TYRONE TOWNSHIP PLANNING COMMISSION
REGULAR MEETING AGENDA
June 8, 2021 7:00 p.m.

Lake Urban Crossing Preliminary PUD Plan

Planned Unit Development Concept Review for Tyrone Township, Michigan

Planned Unit Development Concept Review (2nd) for Tyrone Township, Michigan

SITE PLAN
AND
PARTIAL SITE PLAN

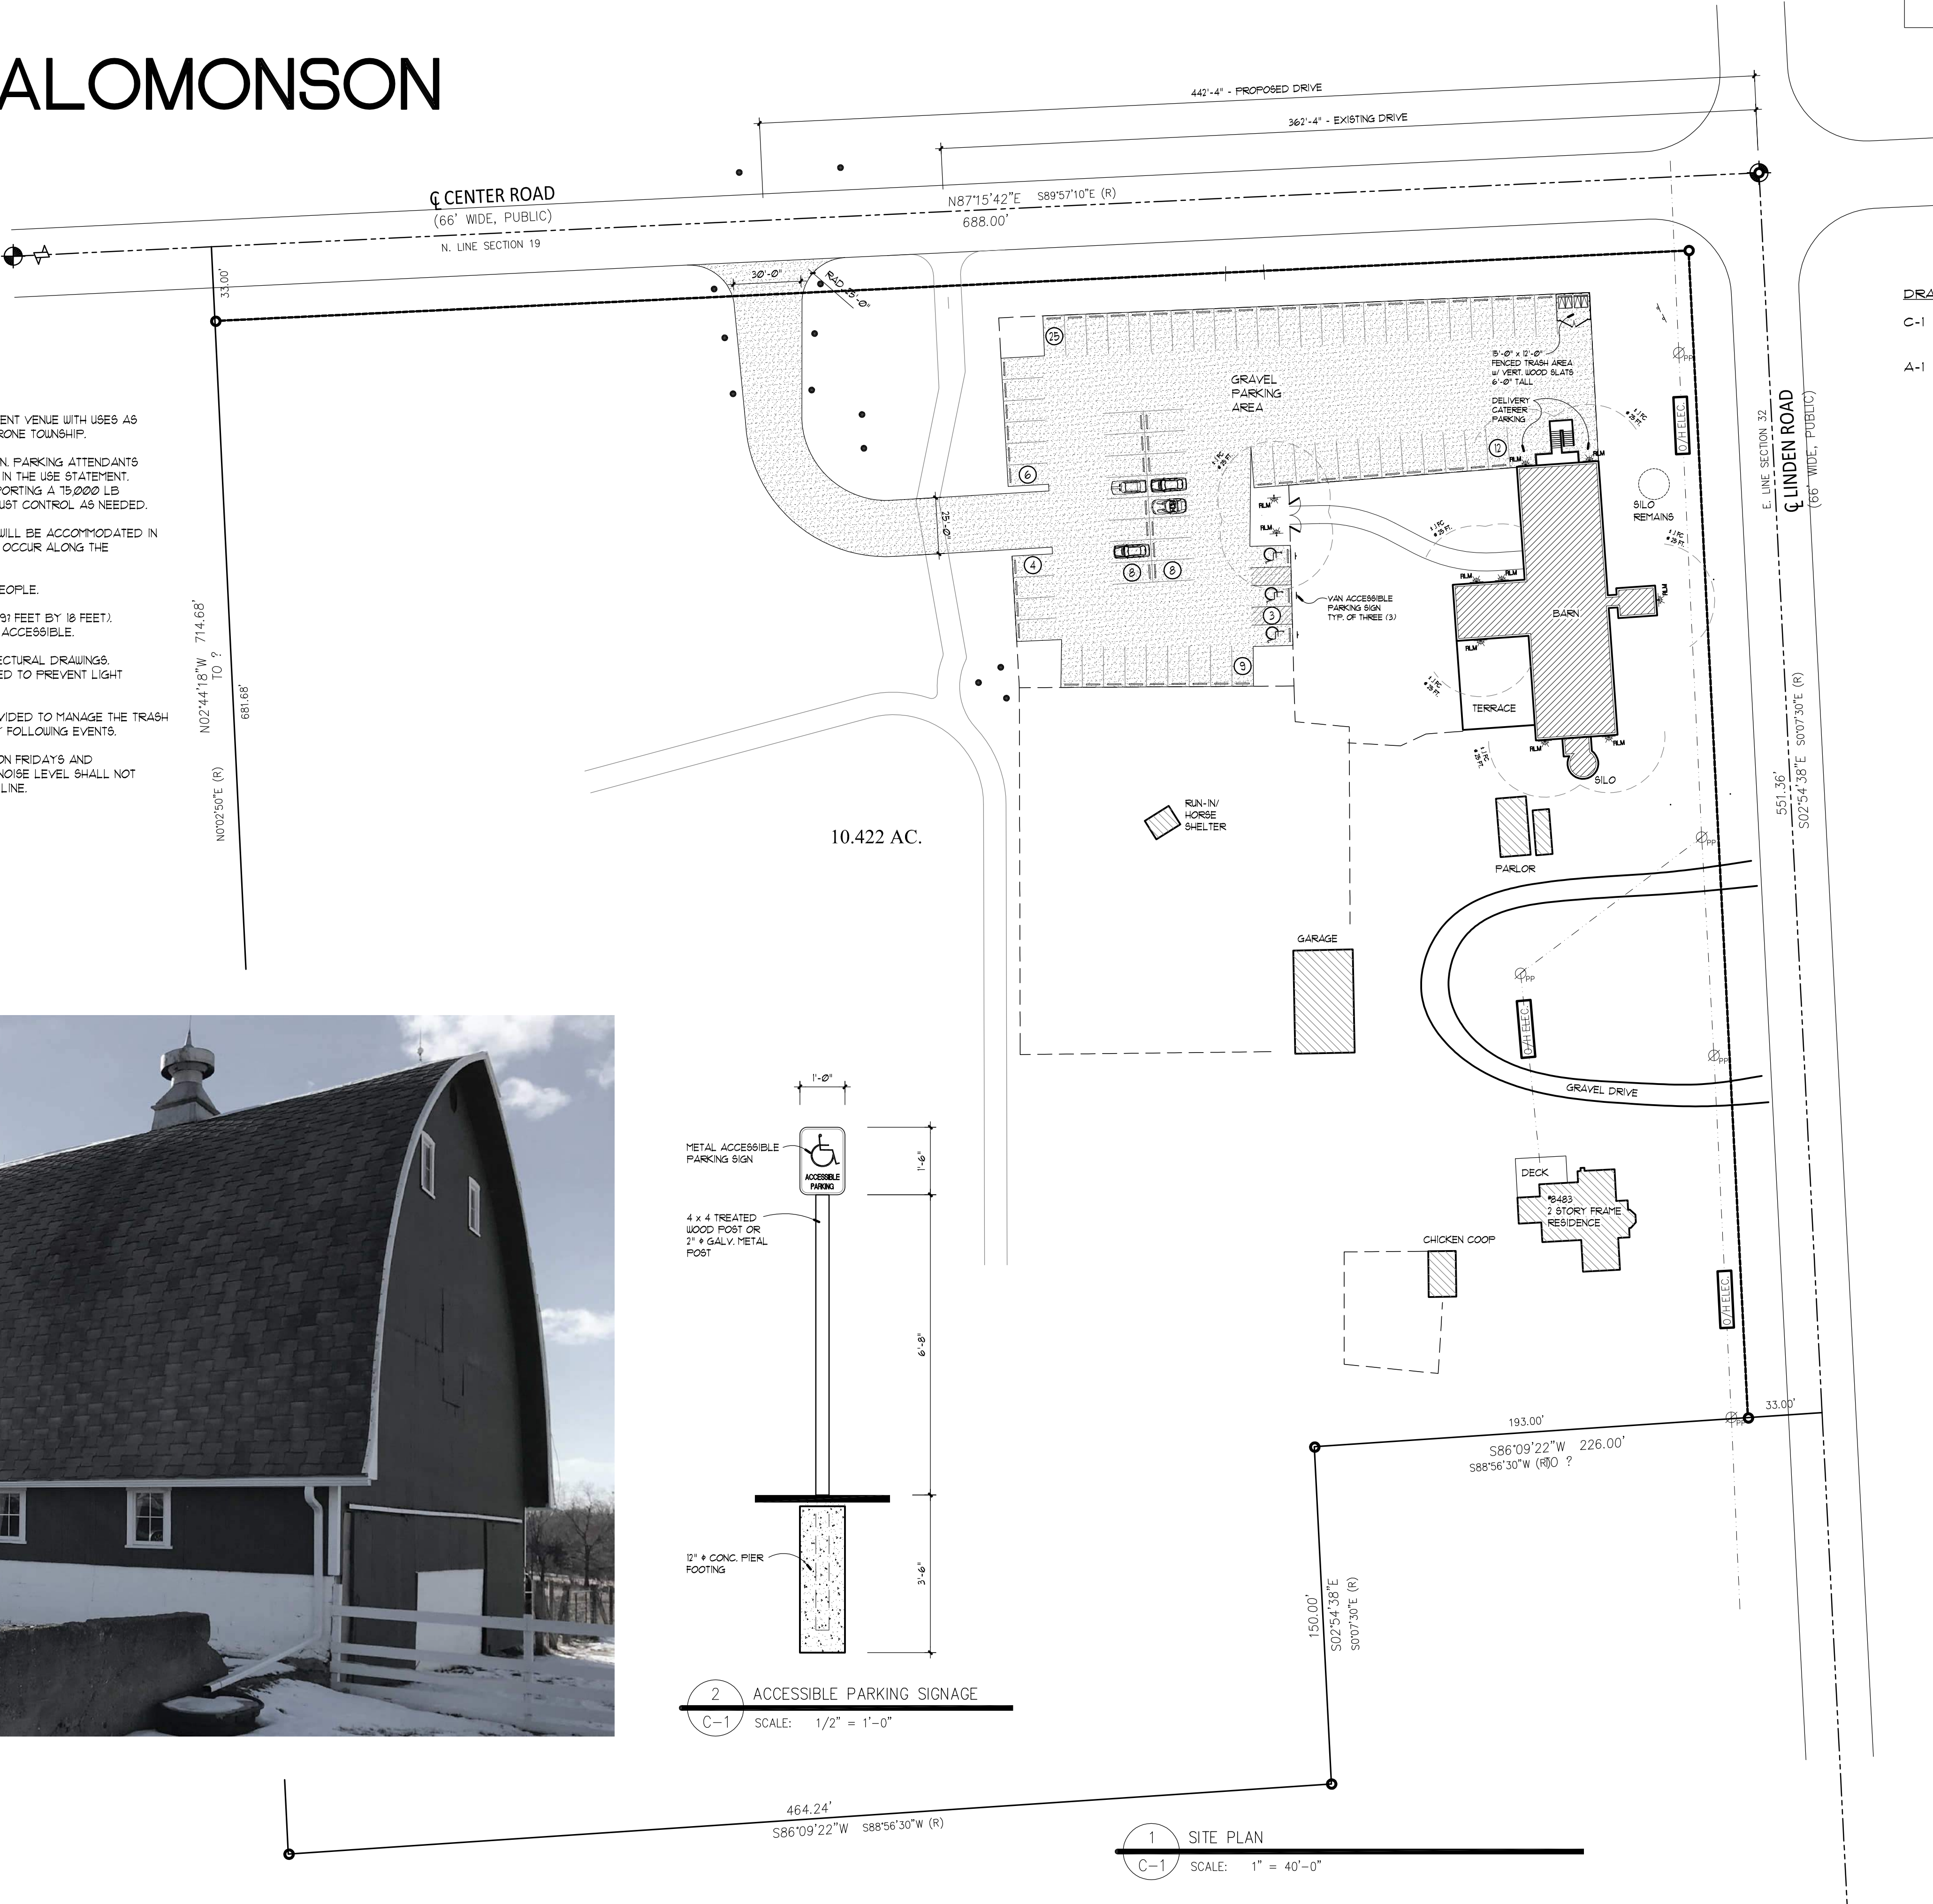
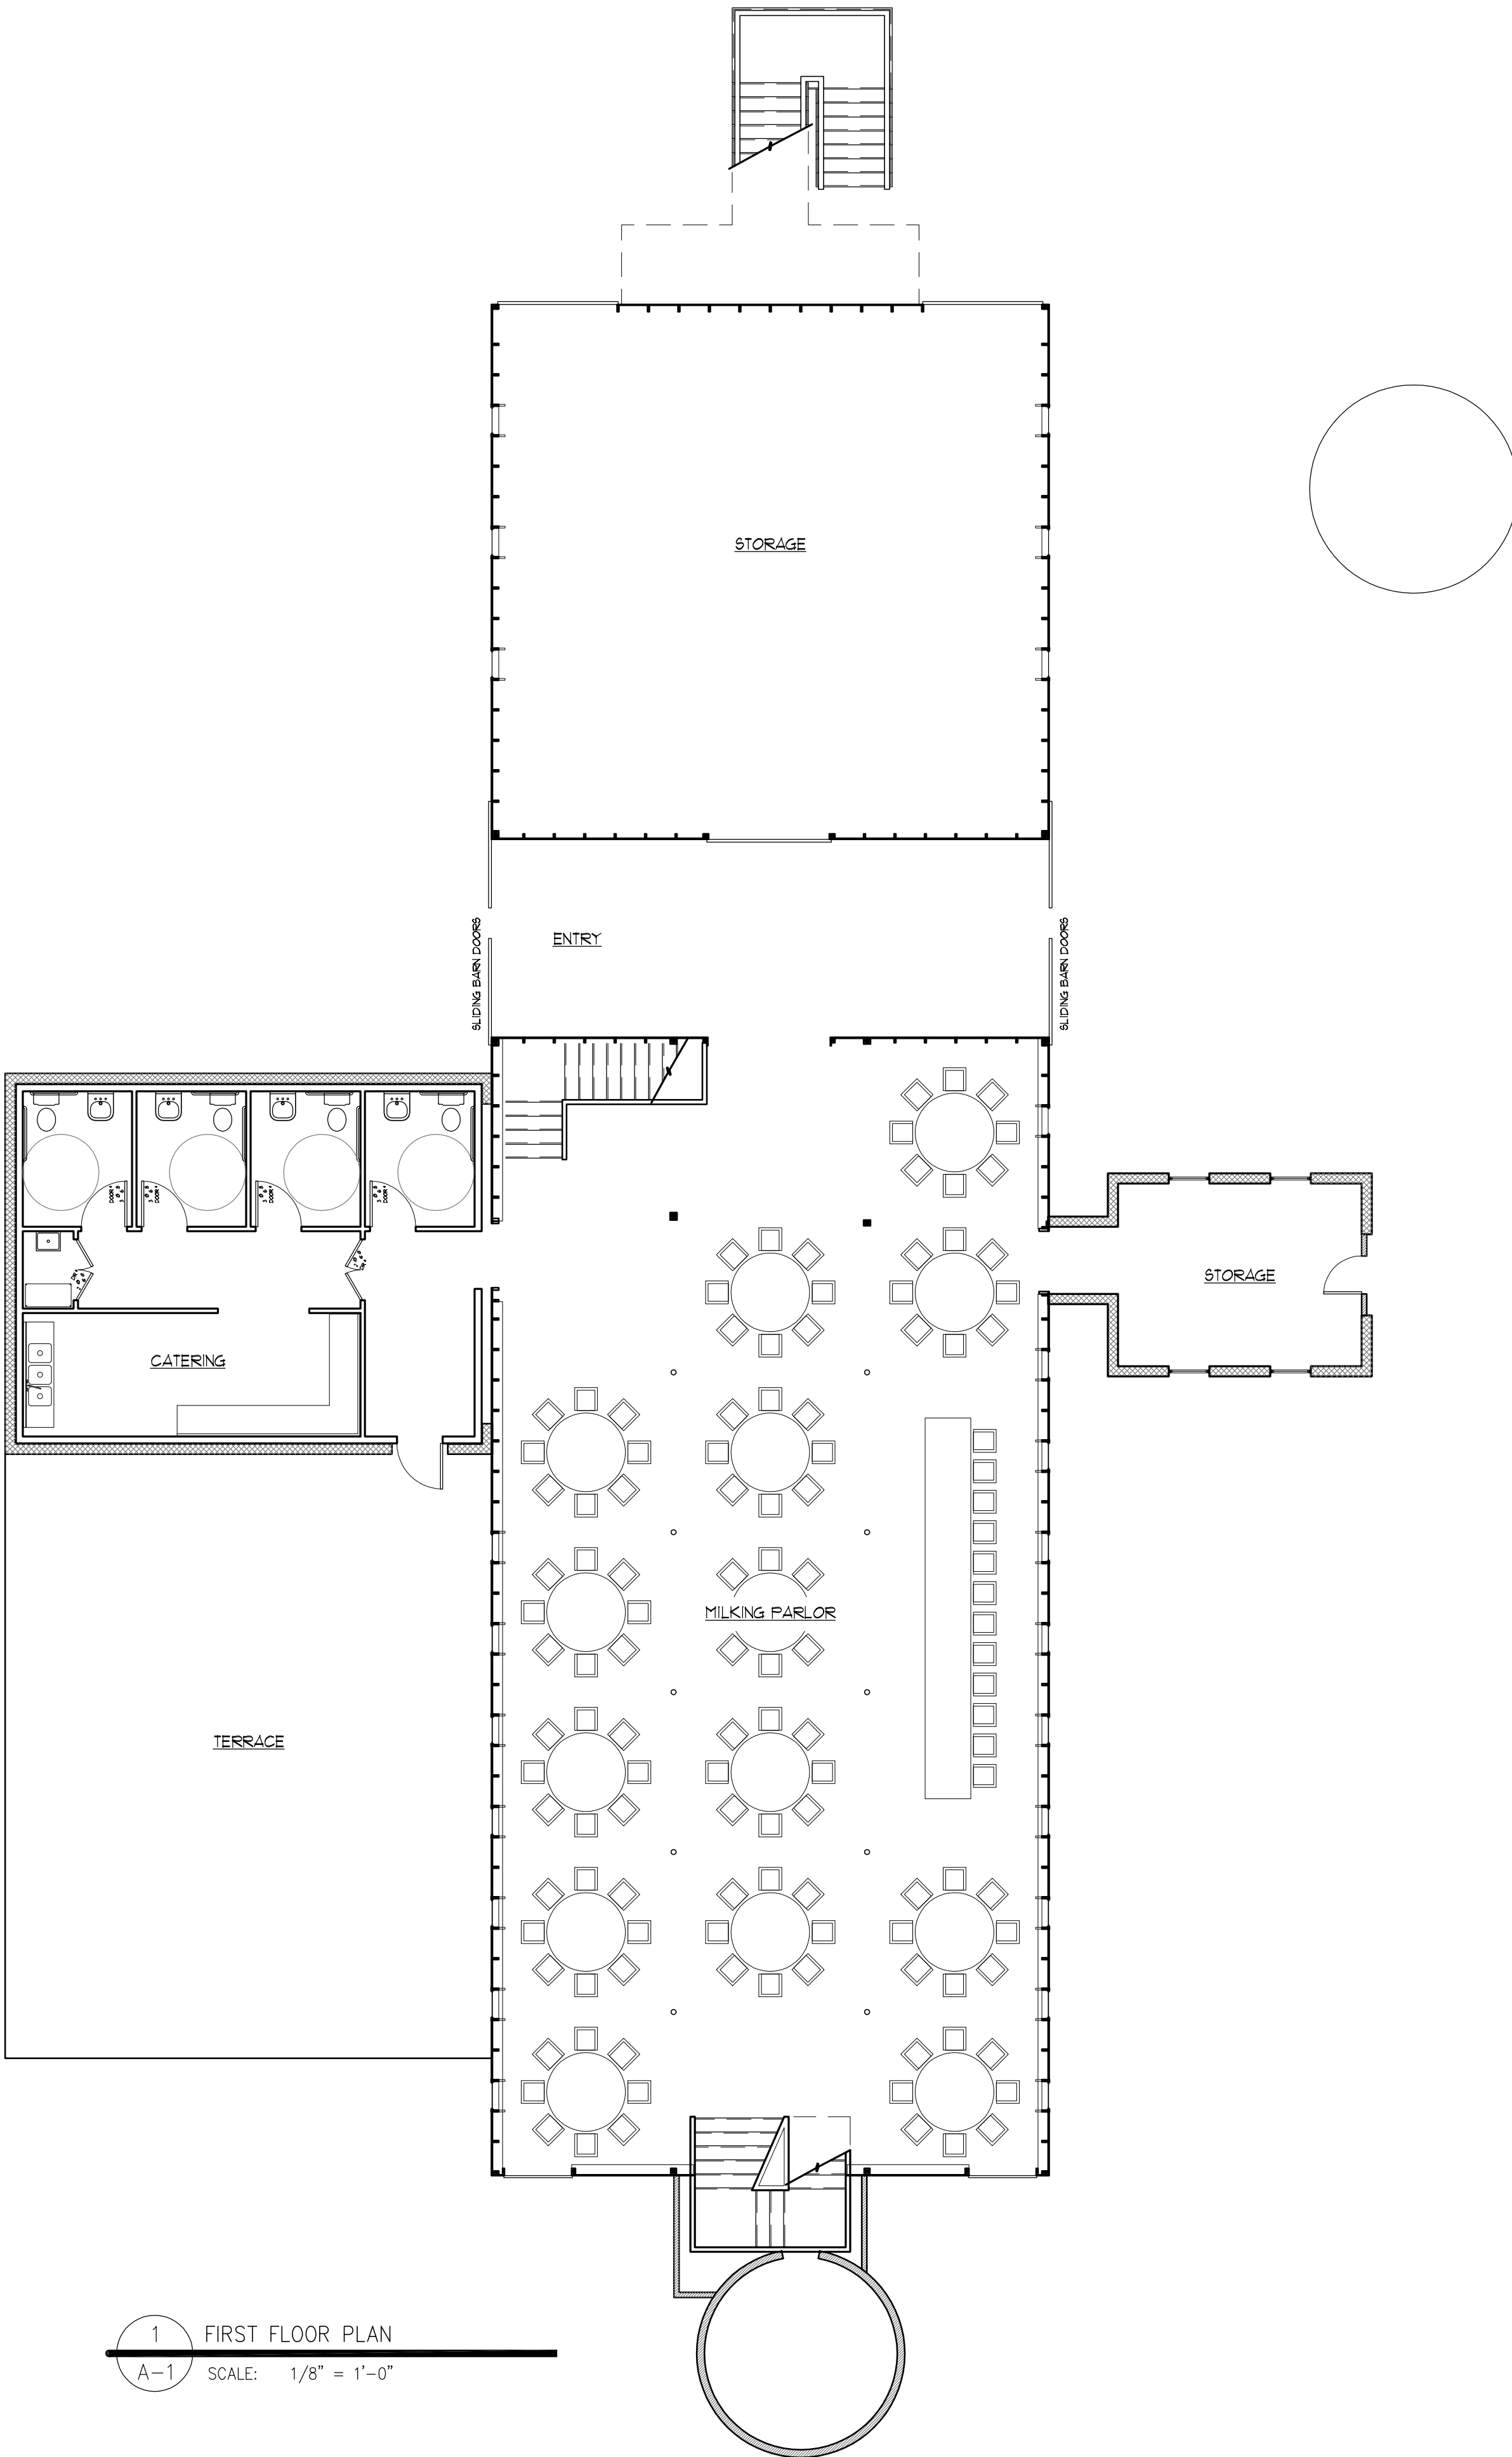
The plan shows that there will be 74 parking spaces, including 3 accessible spaces. The site plan notes on sheet C-1 indicate there will be 75 spaces. The number of parking spaces should be tied with the capacity of the site rather than just the capacity of the barn itself. There will also be loading spaces for catering vans on the north side of the barn.

A note on Sheet C-1 states that lighting will be specified on the architectural drawings and will be shielded and downward facing.
